Village of Arlington Heights
Plan Commission
Board Room
Arlington Heights Village Hall
33 S. Arlington Heights Road
Arlington Heights, IL 60005
February 22, 2017
7:30 PM

- A. Arlington Heights Police Station - 200 E. Sigwalt St. - PC#16-024
Amendment to PUD Ordinances 05-041 and 78-026

Plan Commission Hearing Police Station Round 1
Planning & Community Development Landscape Comment Responses
Charles Witherington-Perkins

SHEET
C-101

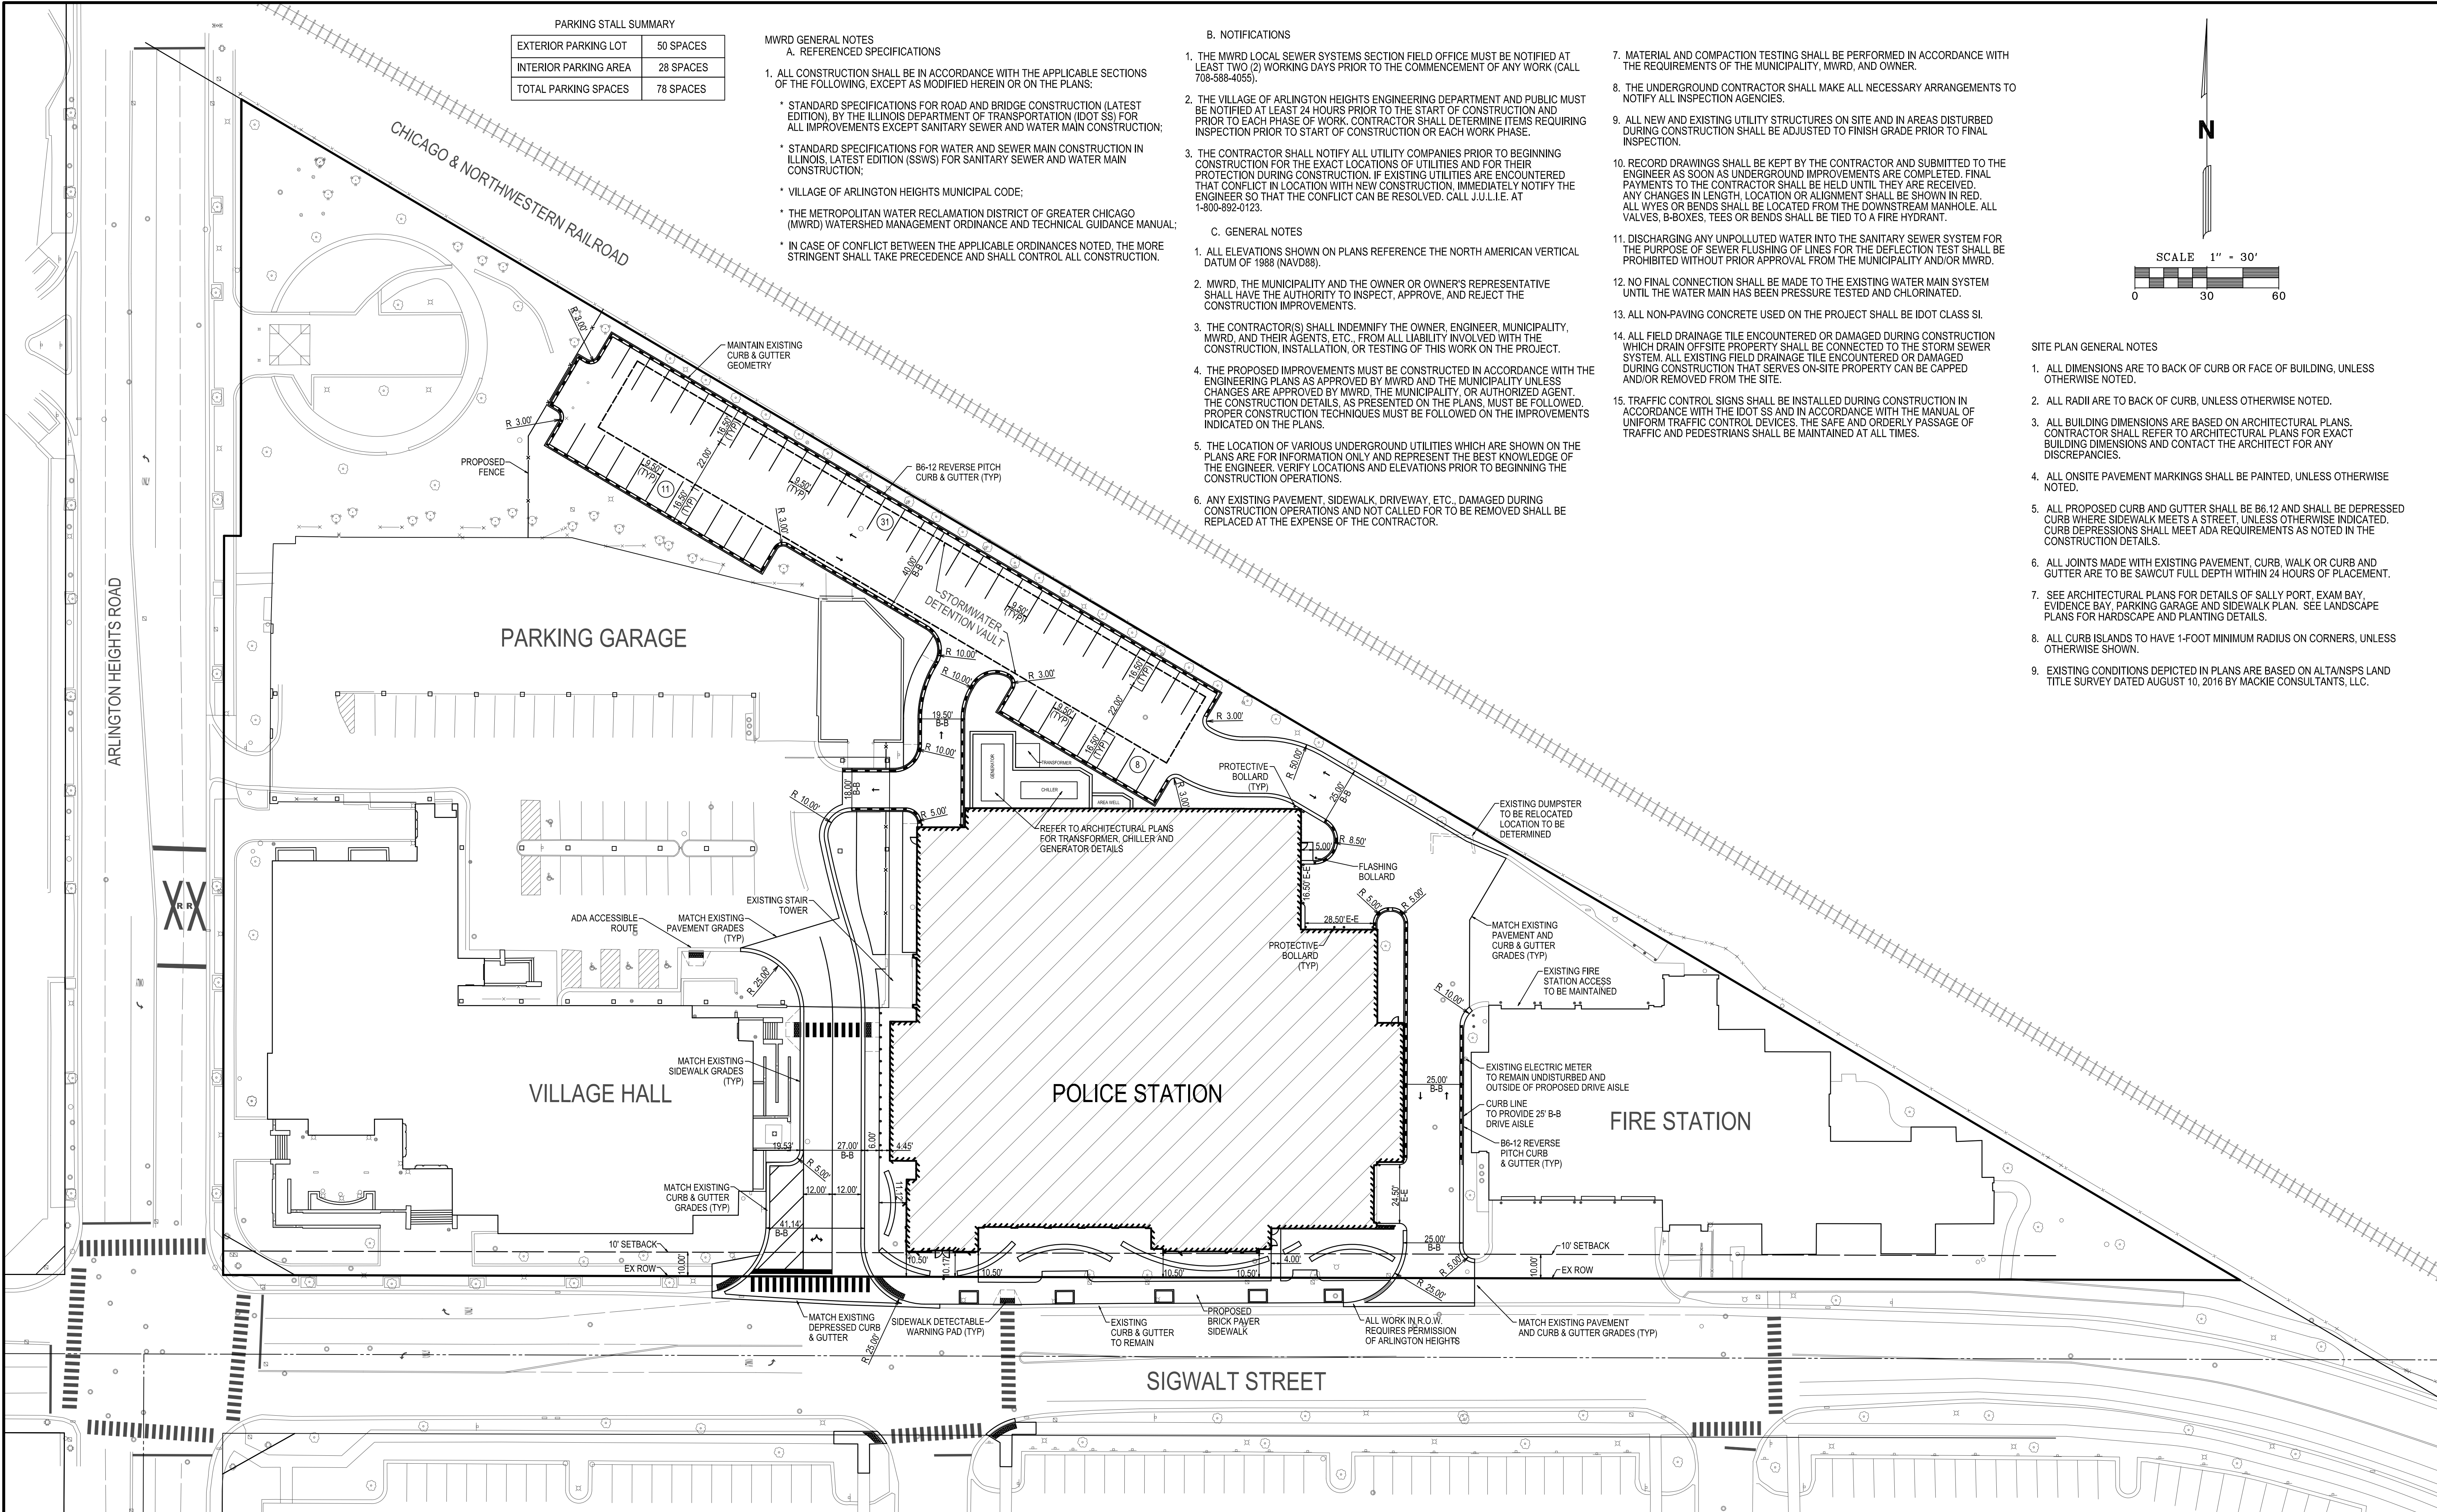
- COMMENT 21:** Sheet C-101: The west driveway shows a through-left lane and a dedicated right turn lane. The traffic report indicates that a single right-thru-left outbound lane will be sufficient, allowing the loading zone to remain. Please show the proper striping/lane usage.

11. Please revise sheet C-101 to indicate the setback distance from the northeast corner of the proposed building to the northern property line.

RESPONSE 33: Based on the proposed geometry reconfigurations at the west driveway, the dimension between the existing Municipal Building and the proposed Police Station will be approximately 57-feet. As discussed with the Village, since the reconfigured geometry further misaligns the outbound thru land to Pine Avenue, the outbound lane has been striped with a right-turn only and left-turn only arrow to assist in identifying the traffic movements to exit the west drive aisle to Pine Avenue. Refer to the Preliminary Overall Site Plan (Sheet C-101).

The distance from the northeast corner of the proposed Police Station building to the northern property line is 30-feet. This dimension has been added to the Preliminary Overall Site Plan (Sheet C-101).

SHEET
C-102

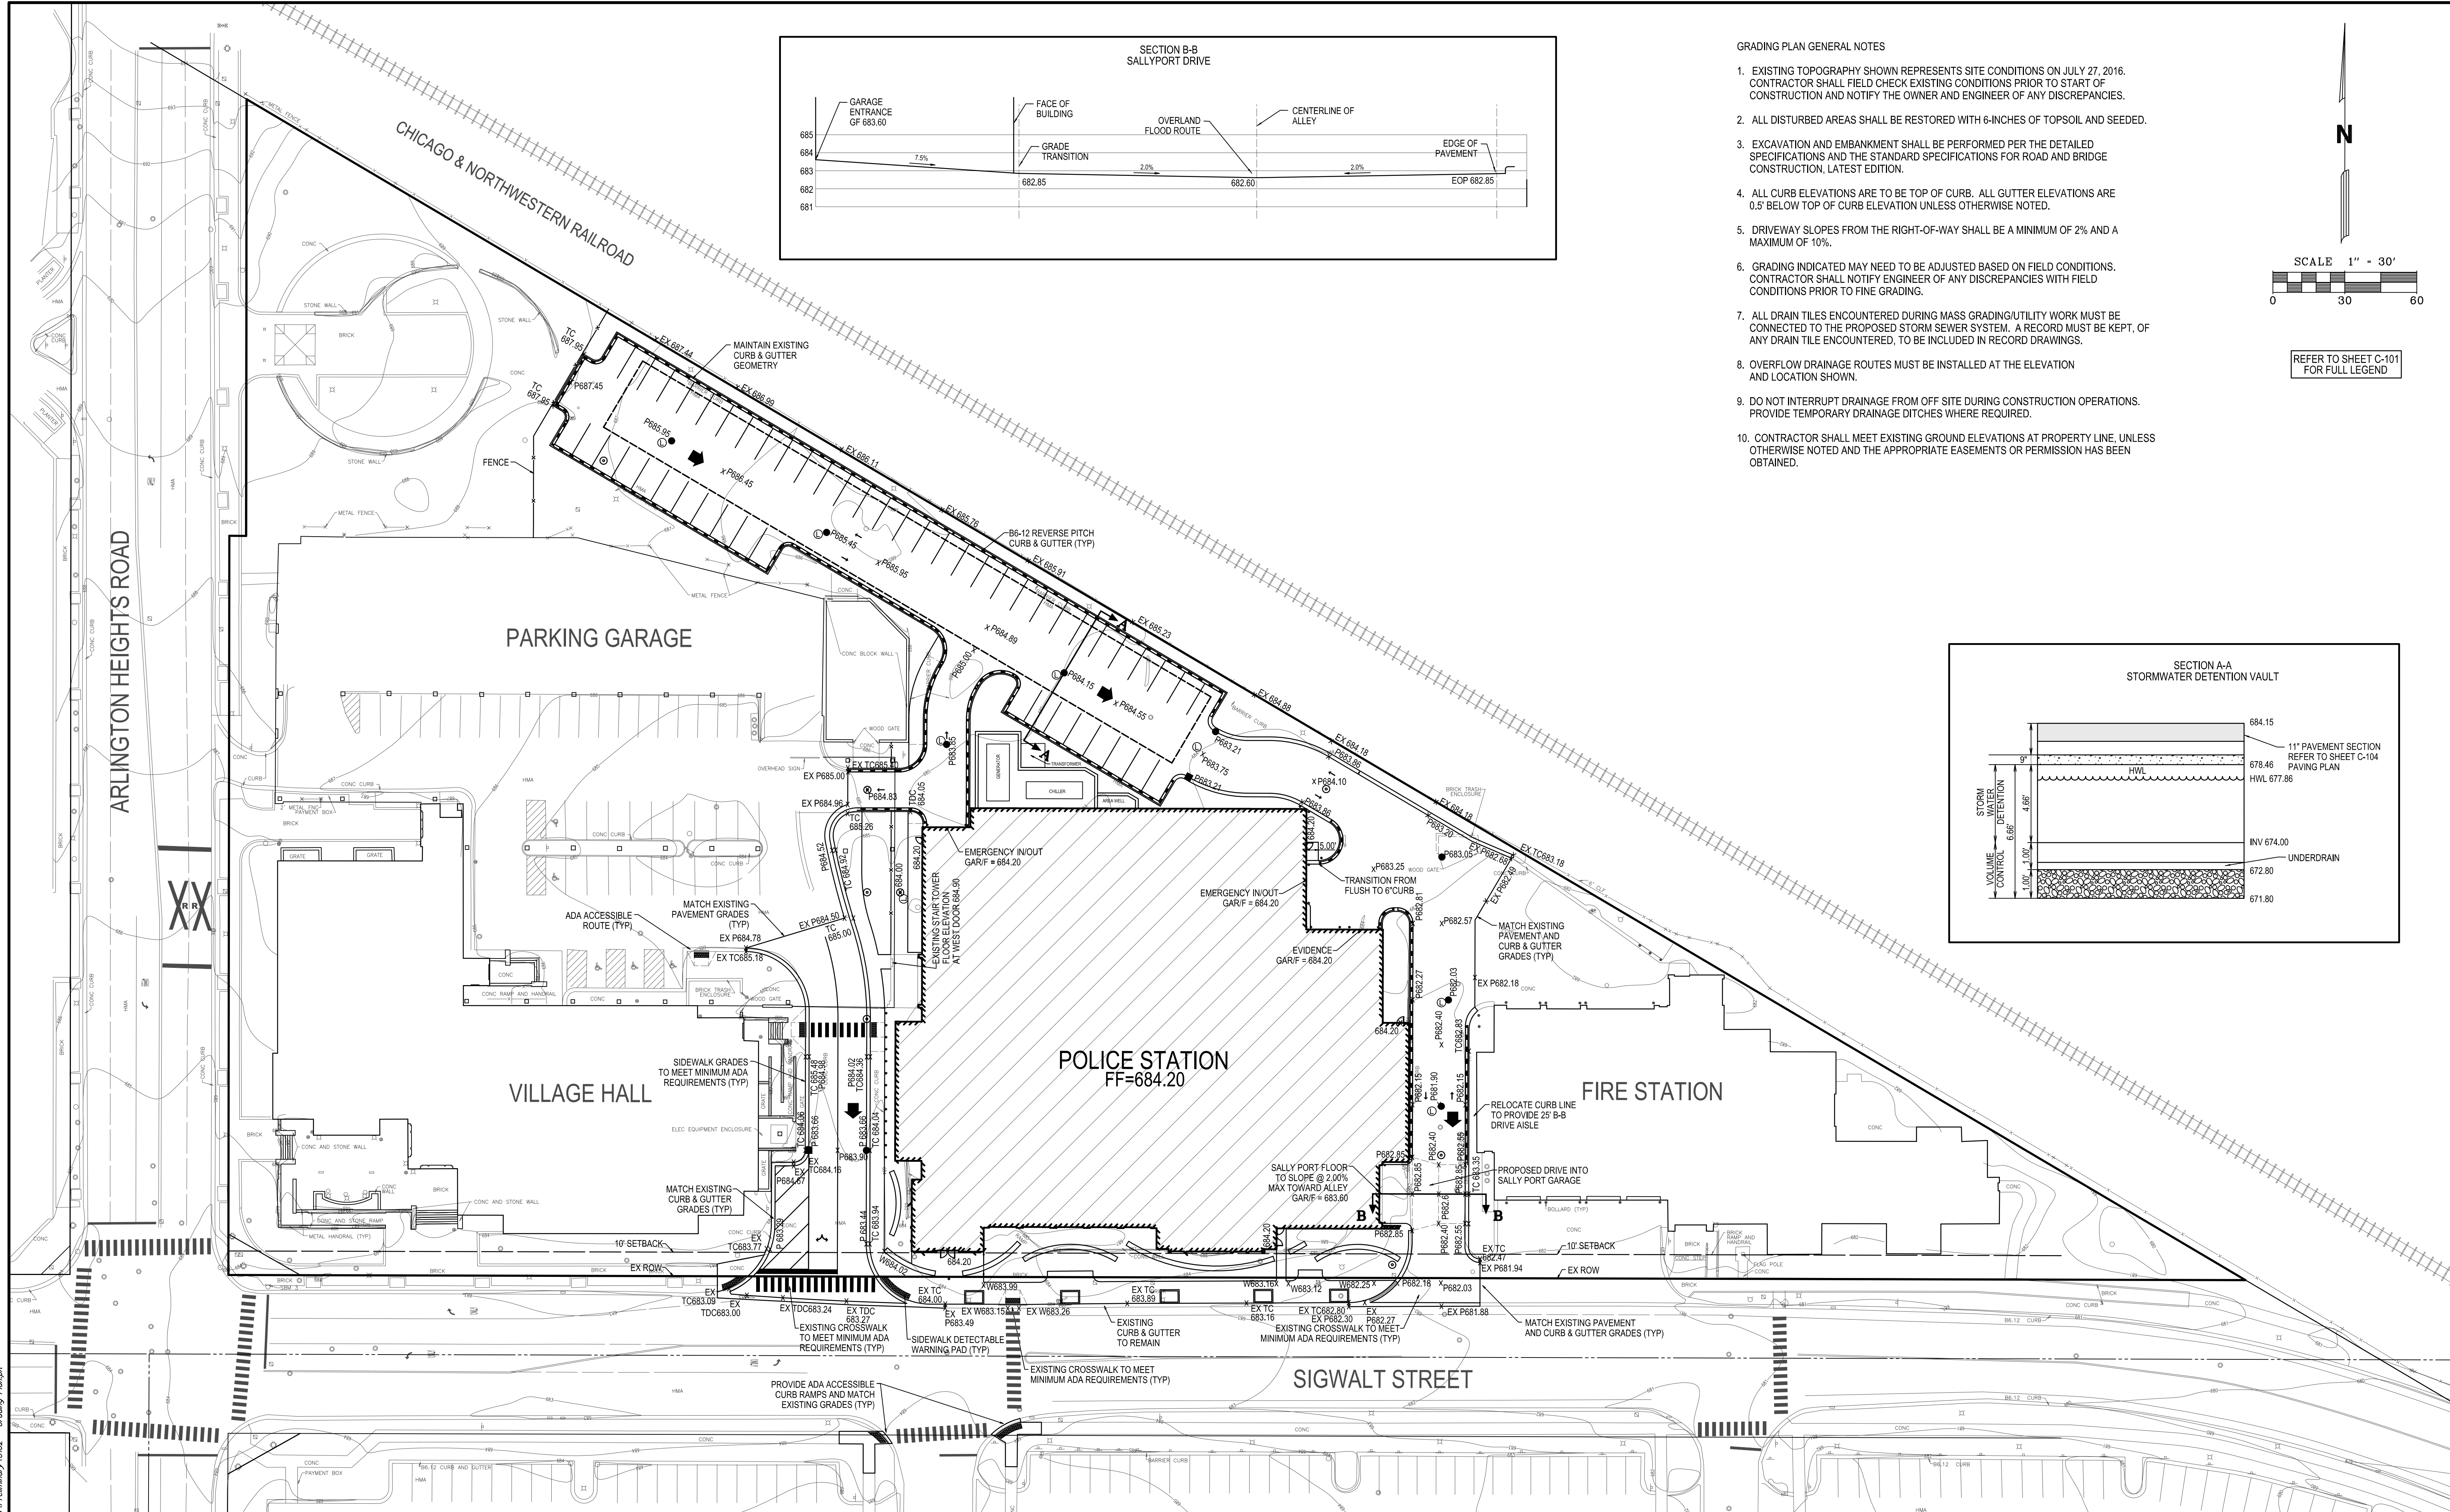
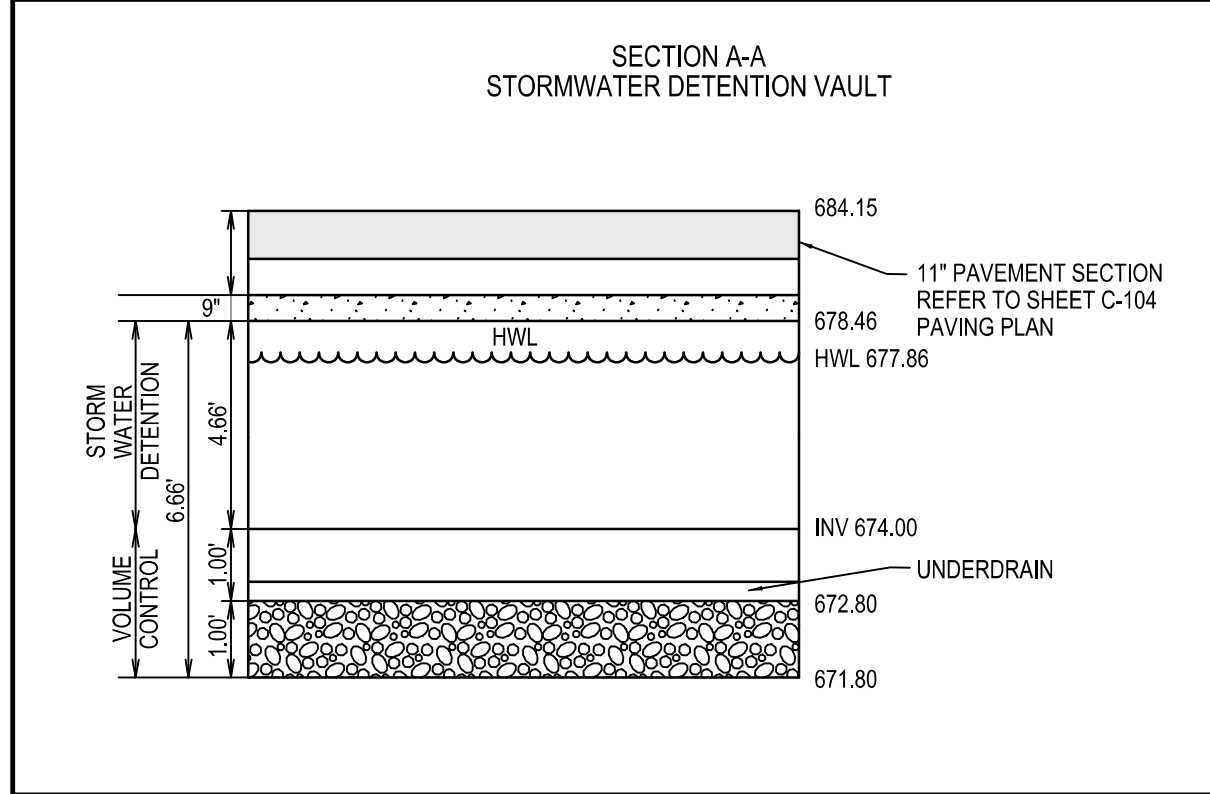
COMMENT 17: Sheet C-102: The detail for Section A-A Stormwater Detention Vault shows a vault interior roof elevation of 678.46, almost 2.5' higher than the proposed HWL. Understanding this is a preliminary design, final design will require detailed volume calculations for a cast-in-place vault design or manufacturer's cut sheets with provided volumes for a pre-cast vault design. Vault plans to be stamped by a Registered Professional Structural Engineer. Loadings from the nearby railroad tracks should be taken into consideration, as determined by the structural engineer.

- COMMENT 22:** Sheet C-102: Can the interior floor of the Sally Port be lowered or sloped to reduce or eliminate the proposed exterior driveway modifications at the door? The building's finished floor elevation is shown at 684.20 and the garage floor elevation at the Sally Port door is the same.

- COMMENT 23:** Sheet C-102: Clearly show the overflow route for surface water. Ensure via weir calculations that the proposed modifications to the driveway in front of the Sally Port do not impede any overflow.

- RESPONSE 17:** The Preliminary Stormwater Management Calculations have been revised based on Village criteria. Please refer to the revised Stormwater Detention Vault Cross-Section on the Preliminary Grading Plan (Sheet C-102). It is understood that the Final Engineering Plans will require detailed manufacturer's cut sheets with provided volumes for a pre-cast vault design. The vault plans will be stamped by a Registered Professional Structural Engineer and loadings from the nearby railroad tracks will be taken into consideration, as determined by the structural engineer.

- RESPONSE 22:** At the request of the Arlington Heights Police Department, the sally port finish floor elevation has been proposed at the same finish floor elevation of the building interior. This is in an effort to ease the transfer of perpetrator from the sally port into the police station. Per discussion with the Village, the sally port garage floor has been revised to pitch toward the alley to reduce the cross slope of the proposed alley. Alley thru traffic will benefit from the reduced cross slope. Refer to the Preliminary Grading Plan (Sheet C-102).

- RESPONSE 23:** The proposed overflow route for surface water has been added to the Preliminary Engineering Plans with critical cross-section and weir calculations. Please refer to the Preliminary Grading Plan (Sheet C-102) and Preliminary Stormwater Calculations.

C-104

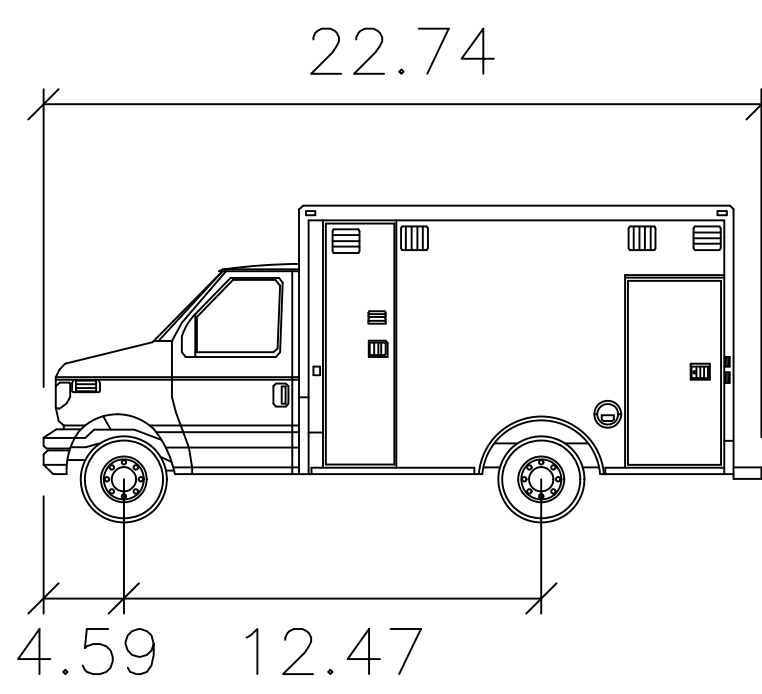
- COMMENT 27:** Sheet C-104: Heavy duty asphalt pavement section to consist of: 2" Surface, 2-1/4" N-50 Binder, 5" N-30 Binder, and 4" CA-6 Stone Subbase.

- COMMENT 28:** Sheet C-104: Based on the pavement widths and the arrows, it appears the drive aisles at the northwest corner of the new building are one-way away from the building. Please confirm this and include the appropriate signage and pavement striping on the final design.

- RESPONSE 27:** The Heavy Duty asphalt pavement section has been revised to match the above specifications. Please refer to the Preliminary Paving Plan (Sheet C-104).

- RESPONSE 28:** The proposed traffic circulation for the development is such that vehicle movements will be one-way from the proposed parking garage to the north and west. Proposed signage and pavement striping has been included on the plan. Please refer to the Preliminary Paving Plan (Sheet C-104).

RESPONSE 34: The public crosswalk and stop bar for the west drive aisle have been moved south to allow outbound traffic to stop closer to the apparent Sigwalt right-of-way. This relocation was reviewed with a 12'x12' sight triangle as suggested by the Village. Refer to the Preliminary Paving Plan (Sheet C-104).

RESPONSE 36: Depressed ADA curb ramps have been added for the sidewalk at the northwest corner of the proposed building for access from the rear parking lot to the Police Station. Refer to the Preliminary Paving Plan (Sheet C-104).
